Project: IEEE P802.15 Working Group for Wireless Personal Area Networks (WPANs)

Submission Title: [802.15.3c comment resolution on #2, 7, 17, 19, 29, and 36]

Re: [In response to IEEE P802.15-08-0020-03-003c-df0-comments]

Figure 18a—Blk-ACK frame format

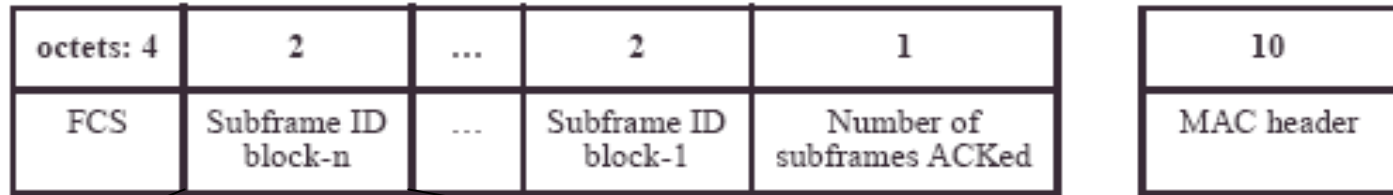
- Issue Number #7 : (1) Will Dly-ACK do what is necessary for Blk-ACK or (2) are there unique things that Blk-ACK needs to do. (3) Also, can this concept be extended to include the AV PHY directional ACK.
- Resolution :
 - (1) Conceptually, Yes,
 - But, Dly-ACK is based on MPDU indication while Blk-ACK is based on subframe indication.
 - Dly-ACK frame format needs to be changed to support aggregation
 - (2) Yes. MSB/LSB indication are included in Blk-ACK.
 - In order for Dly-ACK to keep current functionality of Blk-ACK, Dly-ACK should preserve MSB/LSB indication.
 - (3) Need more discussion.

- Blk-ACK is suggested to be eliminated from baseline document and use Dly-ACK with suggested changes

- Blk-ACK frame format in P802-15-3c-DF1

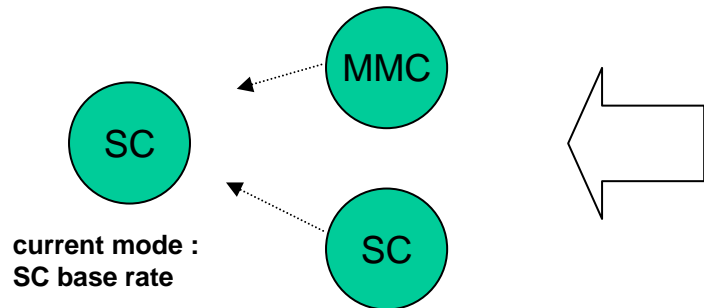
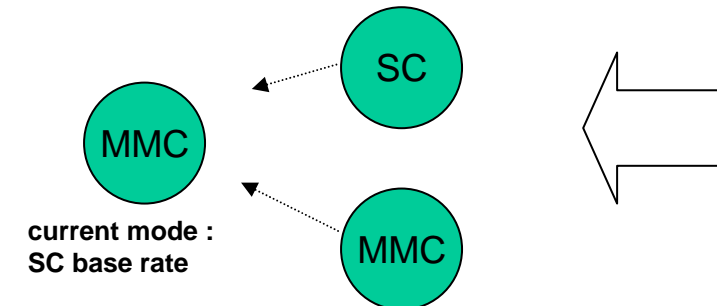
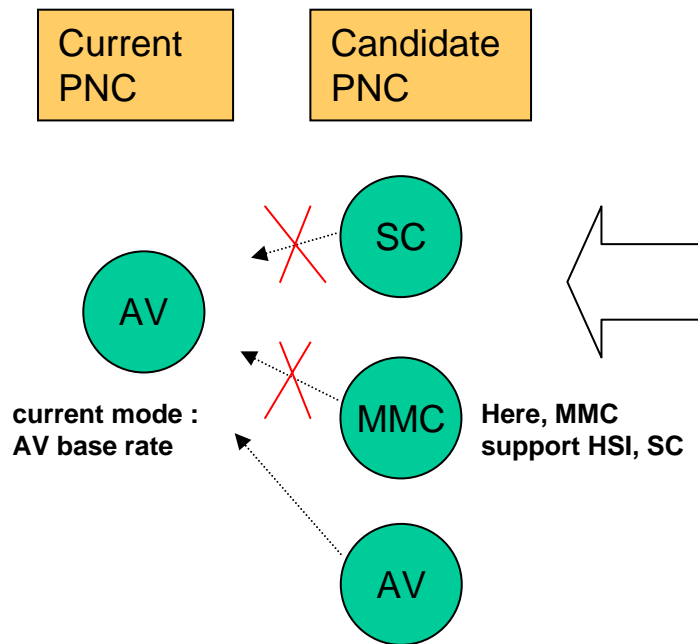
- Issue Number #19 : Need rules to describe that the beacon PHY mode shall not change while in operation. Also, that on handover, the new PNC uses the same PHY mode for the beacon as the old PNC. If so, we may be able to leave PNC Des-Mode as the top criteria for handover.
- Resolution : MMC (a PNC capable device supporting multiple PHYs) would be more desirable to be PNC since it supports SC base rate. But we need a restriction that device being handed over should maintain current transmission mode after handover. For example, current device is SC and candidate device is HSI/AV OFDM capable. After handover, it shall maintain SC base rate.

- Devices between different PHYs can not communicate with each other. Only way to communicate between devices thru either.
 - Same PHY
 - SC base rate

• MMC PNC (same transmission mode + multi-mode) is first priority and SC (same transmission mode) is second priority.

- Since AV PNC only support AV PHY, it can't talk with SC or MMC
- So SC/MMC can't be heard and can't be candidate PNC
- Only device supporting AV can be candidate.

- Suggest Priority order (on the table 55 in P802.15-3c-DF1)
 - 1. PNC desire mode
 - 2. Same transmission mode
 - 3. MMC
